ROSEFIELD SUBDIVISION

APPLICATION NUMBER 6 DATE June 4, 2015

REQUEST Subdivision

DETAIL SITE PLAN

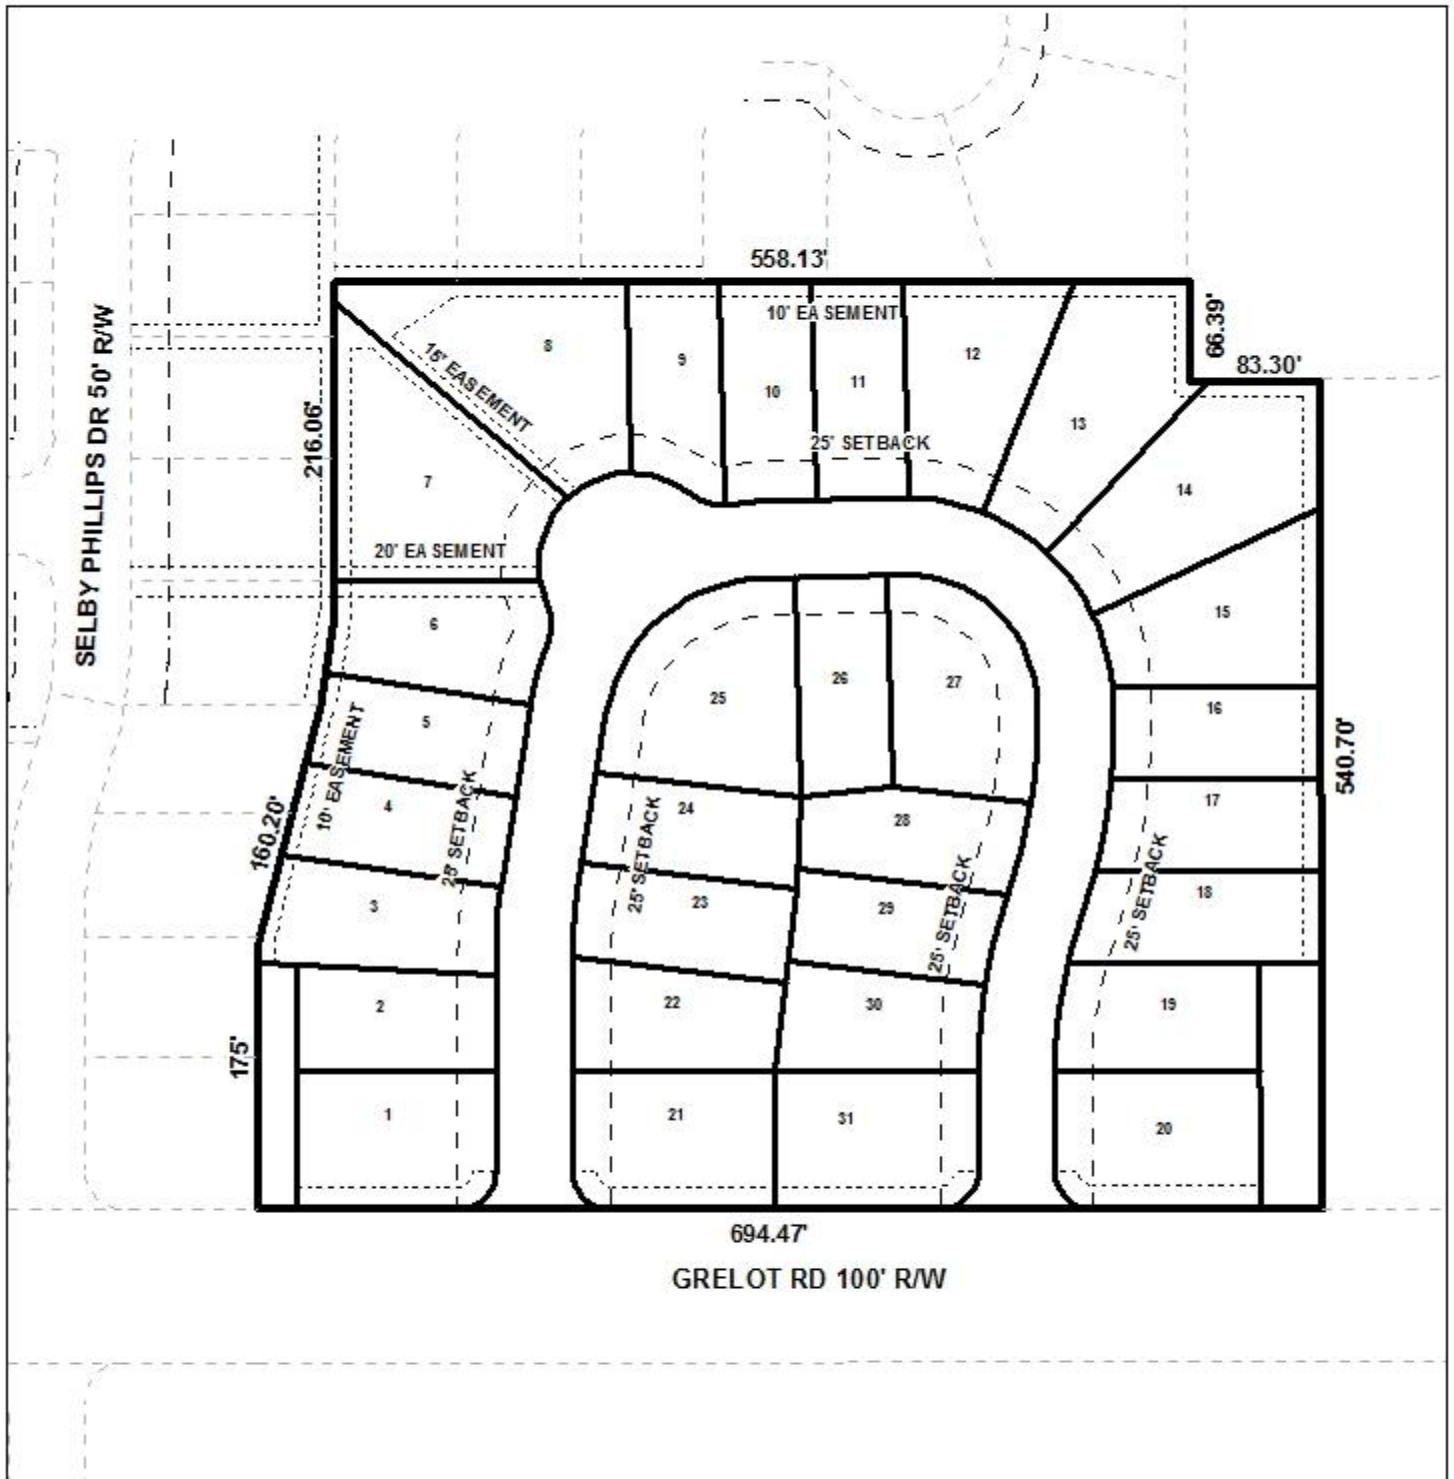
The site fronts Grelot Road, a proposed Major Street, with a compliant right-of-way width via County acquisitions. Therefore, no further dedications would be required. The 25' minimum building setback line along all street frontages, except Grelot Road, is shown on the plat and should be retained on the Final Plat. The plat should also be revised to illustrate the 25' minimum building setback line along the Grelot Road frontage.

As a means of access management, a note should be required on the Final Plat stating that all lots are limited to one curb cut, with the location, size, and design of all curb cuts to be approved by County Engineering, and conform to AASHTO standards. A note should also be required on the Final Plat stating that Lots 1, 20, 21 and 31 are denied direct access to Grelot Road.

All lots meet the minimum size requirements of the Subdivision Regulations. As on the preliminary plat, all lots should be labeled on the Final Plat with their sizes in both square feet and acres, or a table should be furnished on the Final Plat providing the same information

The preliminary plat illustrates two common areas. As on the preliminary plat, a note should be placed on the Final Plat stating that the maintenance of the common areas is the responsibility of the property owners and not Mobile County. The plat also indicates numerous drainage, utility, fence and landscape easements running within the Subdivision boundaries. A note should be required on the Final Plat stating that no permanent structures may be placed or constructed within any easement.

- 2) retention of the 25' minimum building setback line along all street frontages as shown on the preliminary plat;
- 3) revision of the plat to also indicate a 25' minimum building setback line along the Grelot Road frontage;

- 5) placement of a note on the Final Plat stating that Lots 1, 20, 21 and 31 are denied direct access to Grelot Road;
- 6) retention of the labeling of all lots with their size in both square feet and acres, or the furnishing of a table on the Final Plat providing the same information;
